Access Compliance Report

Public Rights-of-Way

(Curb Ramps)

Intersection ID: 50604	Main Street: RHODORA_RD	Cross Street: LAMINA_CT	Location: SW
ADA ID: 38299F4F659F	Ramp Type: Perp	Initial Pass/Fail: Fail	Overall Compliance: No
Severity Score: 10			
Codes/Mitigation Info/Possible Solution		Field Measurements/Component Compliance

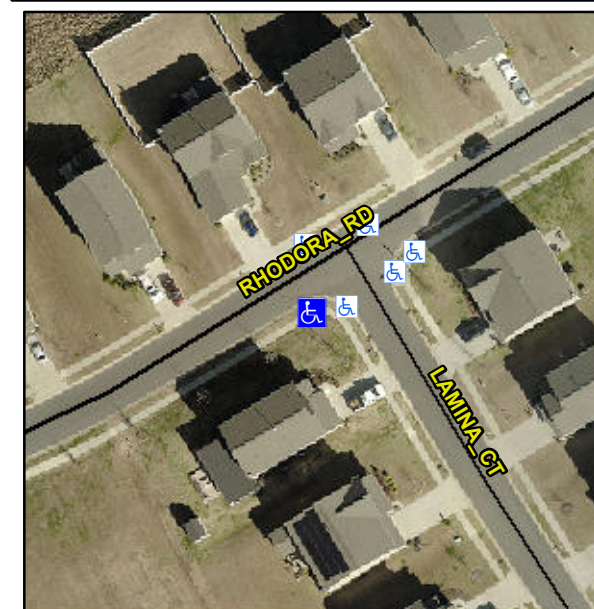
Not Found, R304.5.1

Compliance	Description	Data	Compliance	Description	Data
N/A	Ramp Length (in)	49.0	Yes	Ramp Slope (%)	6.5
No	Ramp Width (in)	46.5	Yes	Ramp XSlope (%)	2.6
N/A	Flare Type LT	N/A	N/A	Flare Type RT	N/A
N/A	Flare Slope LT (%)	N/A	N/A	Flare Slope RT (%)	N/A
N/A	Flare Traversable LT?	N/A	N/A	Flare Traversable RT?	N/A
N/A	Landing Length (in)	N/A	N/A	DWS Provided?	N/A
N/A	Landing Width (in)	N/A	N/A	DWS Contrast?	N/A
N/A	Landing Slope (%)	N/A	N/A	DWS Length (in)	N/A
N/A	Landing X Slope (%)	N/A	N/A	DWS Full Width?	N/A
N/A	Landing Curb? (Y/N)	N/A	N/A	DWS Offset (in)	N/A
N/A	Shared Landing?	N/A			
N/A	Gutter Ponding?	N/A	N/A	Gutter Slope (%)	N/A
N/A	Gutter Lip Ht (in)	N/A	N/A	Gutter X Slope (%)	N/A
N/A	Painted X Walk1?	No	N/A	Painted X Walk2?	N/A
	X Walk 1 Direction	To N		X Walk 2 Direction	N/A
N/A	X Walk 1 Width (in)	N/A	N/A	X Walk 2 Width (in)	N/A
	X Walk 1 Slope (%)	2.9		X Walk 2 Slope (%)	N/A
	X Walk 1 X Slope (%)	3.2		X Walk 2 X Slope (%)	N/A

Remove & Replace Entire Ramp.
